ADDENDUM NO. 2

VILLAGE OF COVINGTON Wastewater Treatment Plant Improvements Phase II Blower Replacement February 19, 2019

Re: Village of Covington
Wastewater Treatment Plant Improvements Phase II – Blower Replacement

PROJ. NO: CV07112617	DWG. NO: 1D15071	SCALE: AS NOTED
DRAWN: DRM	CHECKED: MJB	DATE: 02/15/19 SHEET NO: 5A OF 9

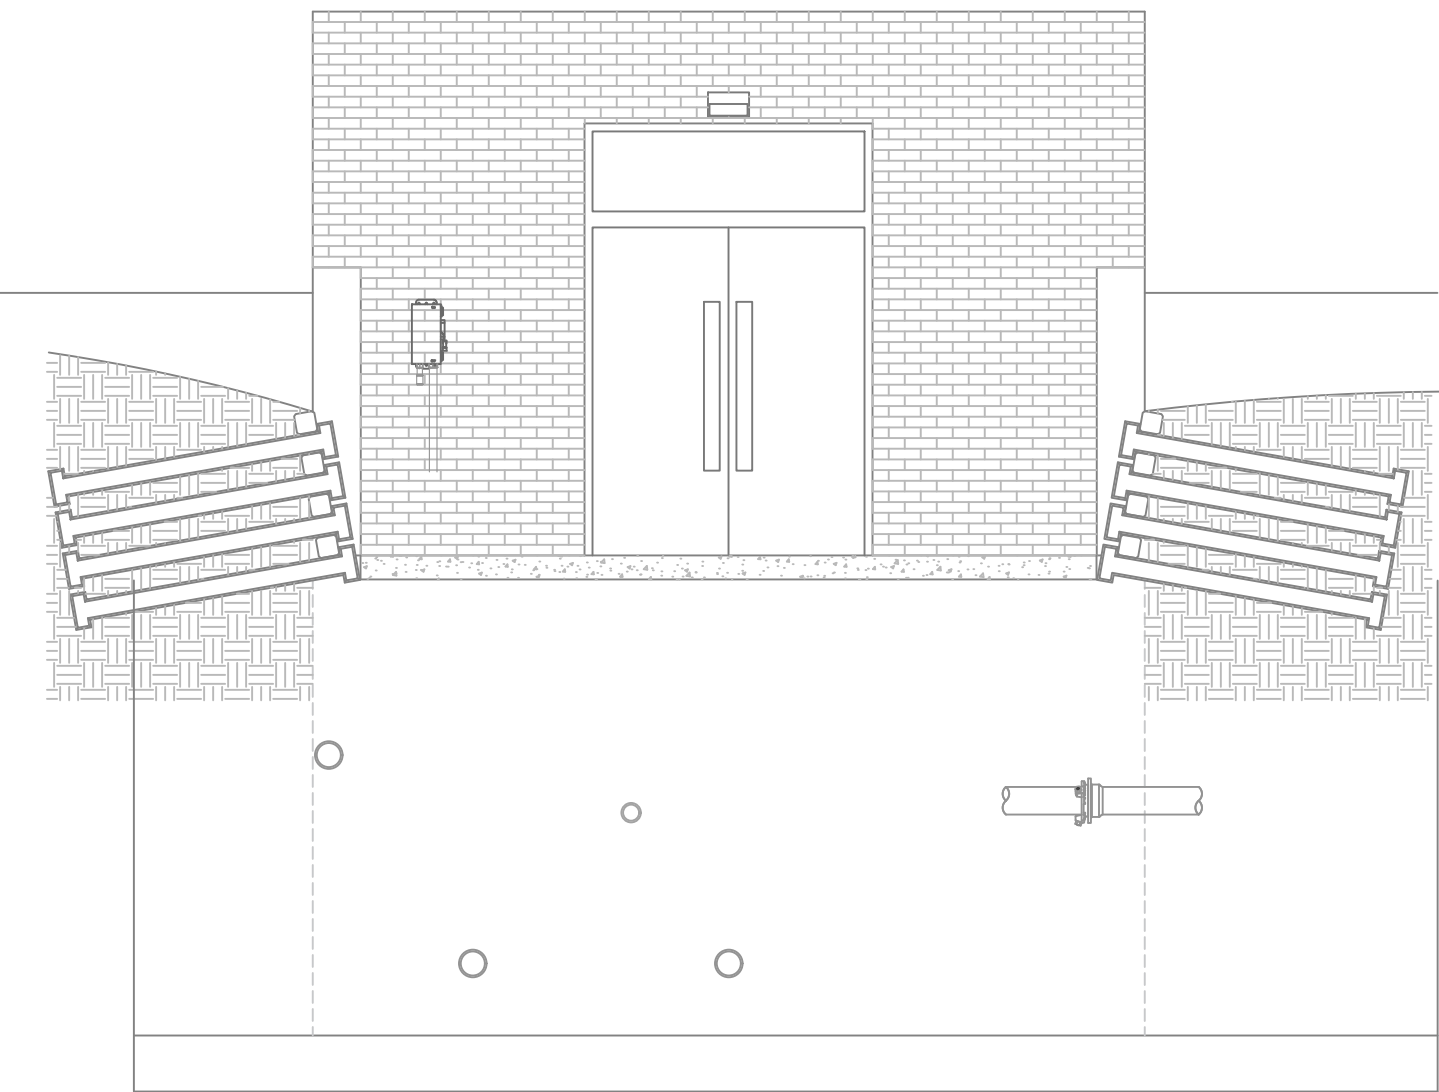
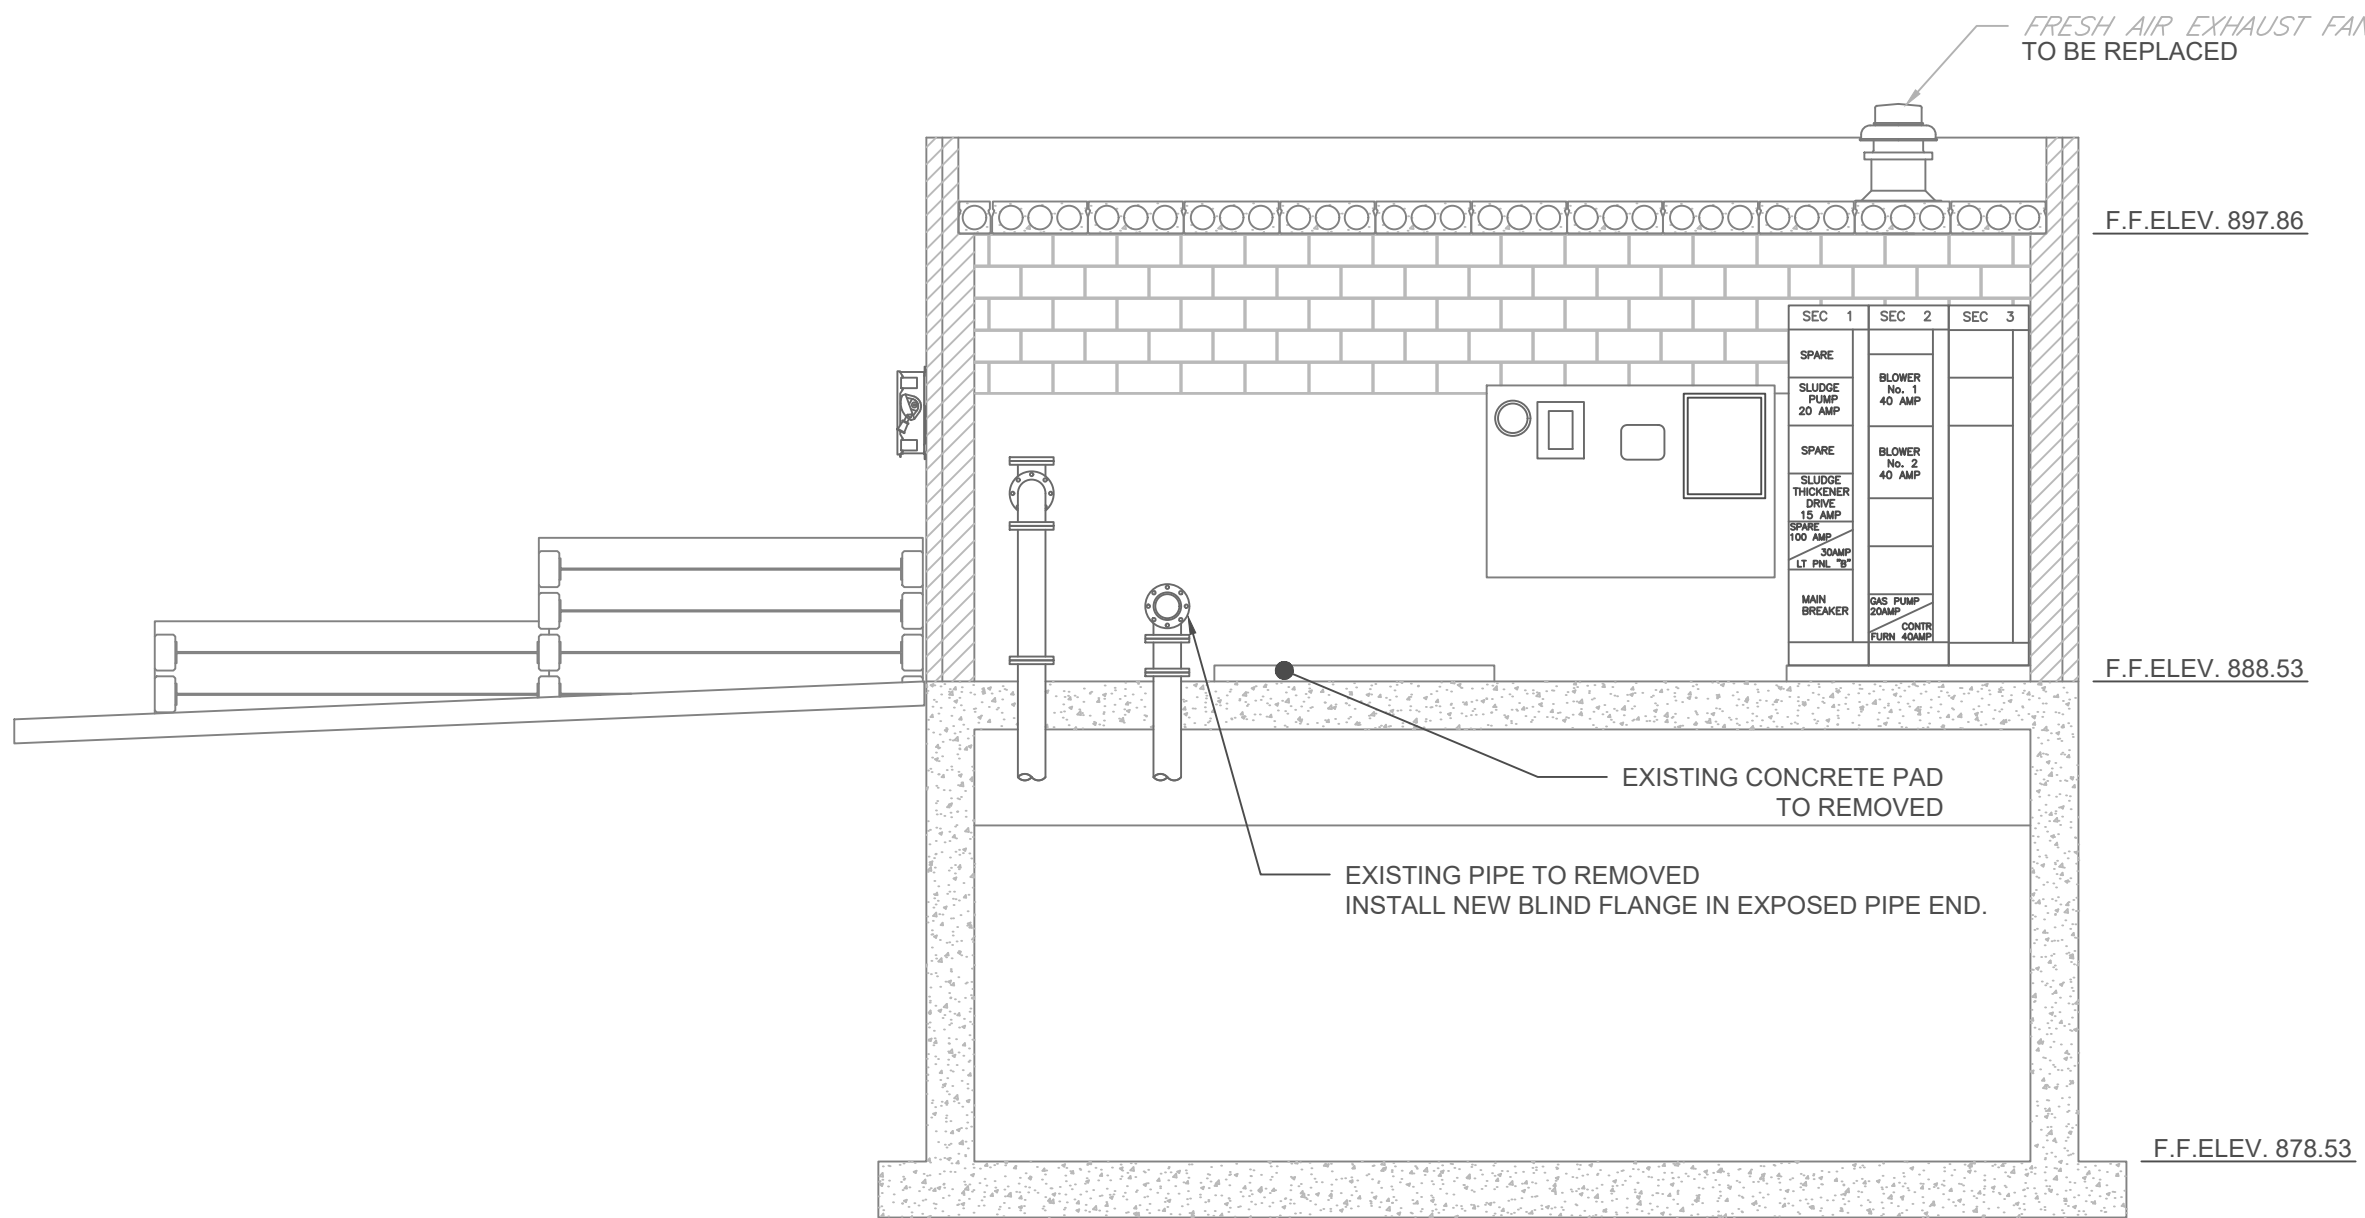
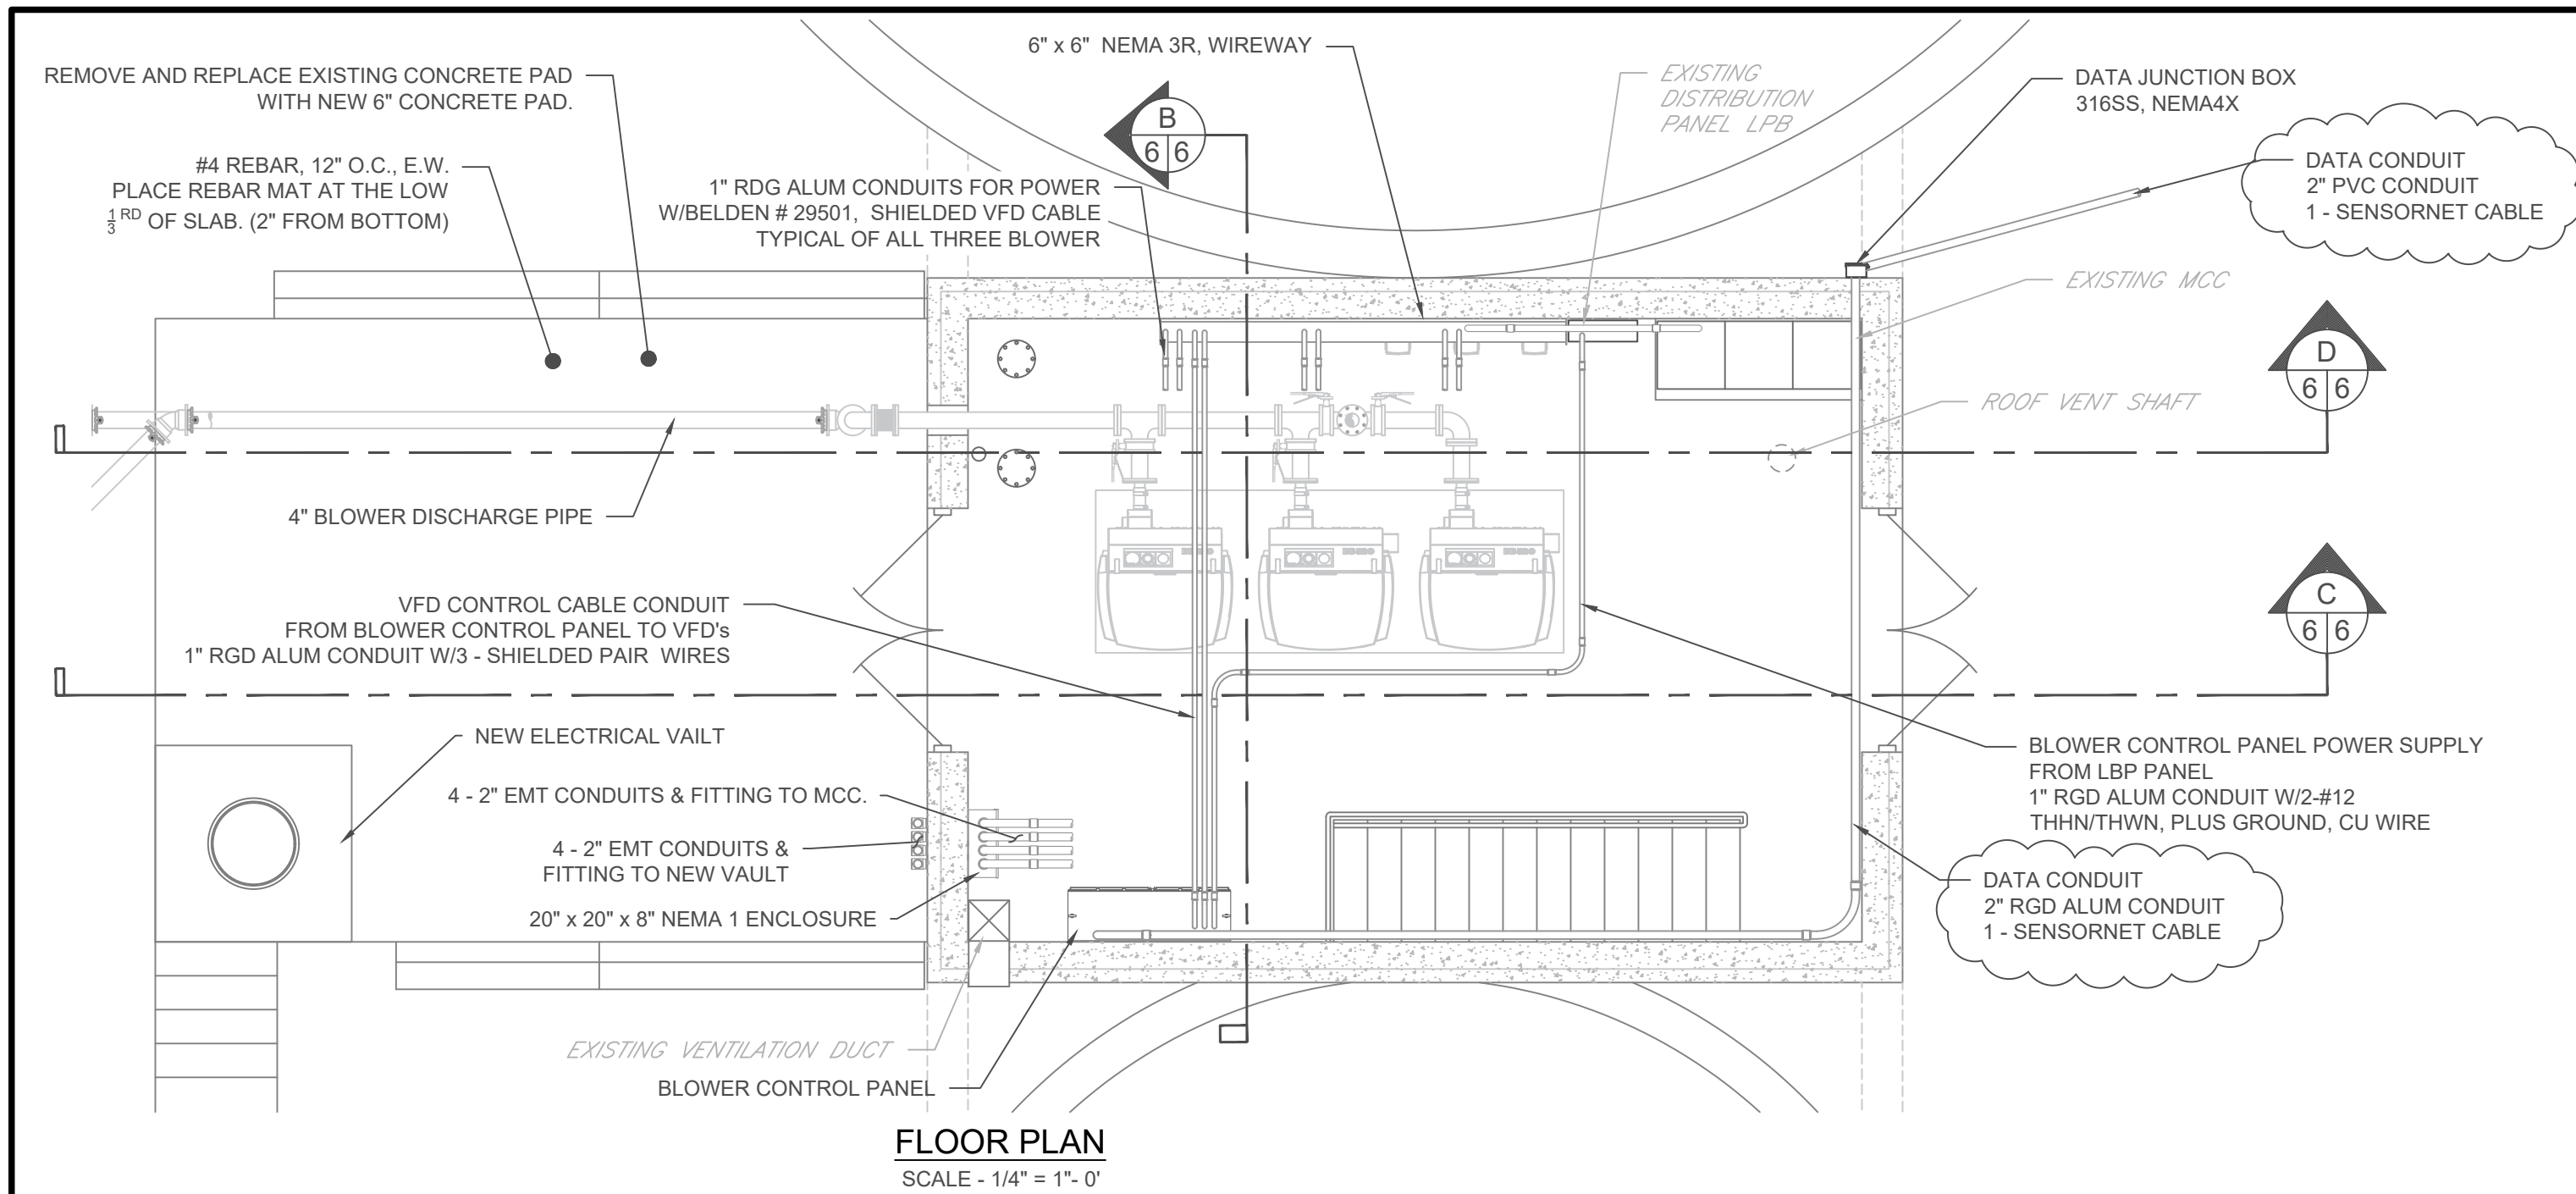
3. Sheet 2A has been updated indicated the amount of air piping to be replaced.
4. Sheets 3A, 4A, 6A, 8A and 9A indicate the changes from fiber-optic to SensorNet Cables.
5. Sheet 5A clarifies the water piping and obsolete equipment to be removed.

DRM	15 FEB 2019	REMOVE FIBER-OPTIC AND REPLACE WITH YSI SENSORNET
-----	-------------	---
